Interactive comment on “An Explicit GIS-Based River Basin Framework for Aquatic Ecosystem Conservation in the Amazon” by Eduardo Venticinque et al.

Anonymous Referee #1

Received and published: 8 August 2016

Fig. 1.

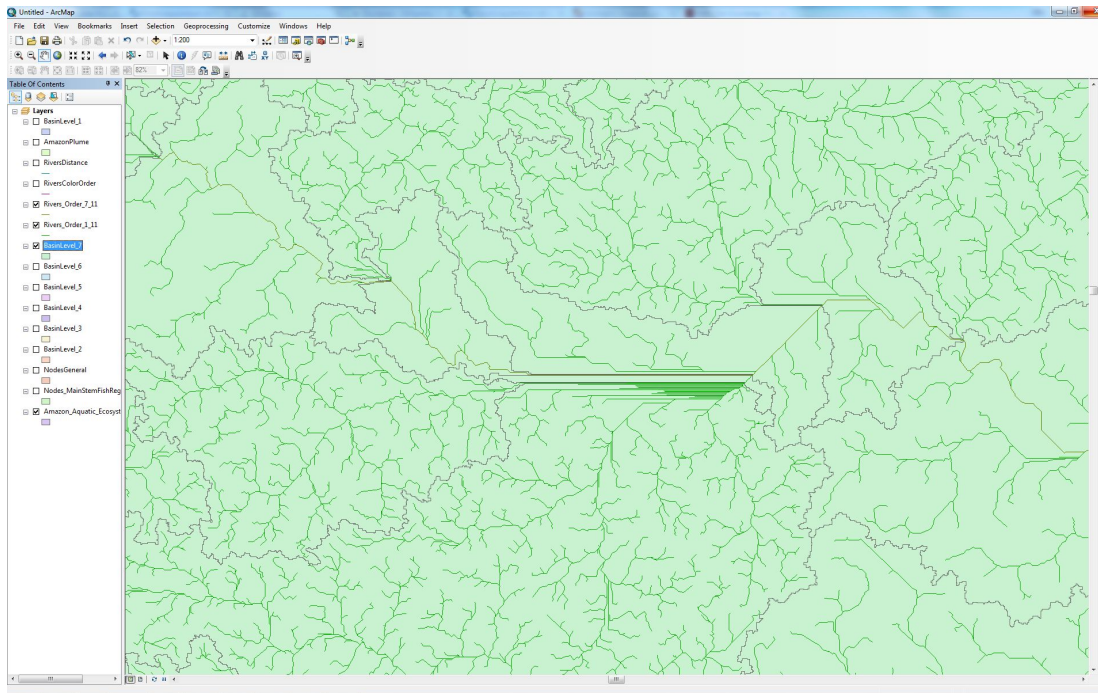
- The generated river network and sub-basins show a large number of artefacts at the higher resolutions (see attached Figs. 1 to 3). This should be discussed in some detail.
- The DEM used for the analysis should also be made available, if possible.
- Many references are missing.
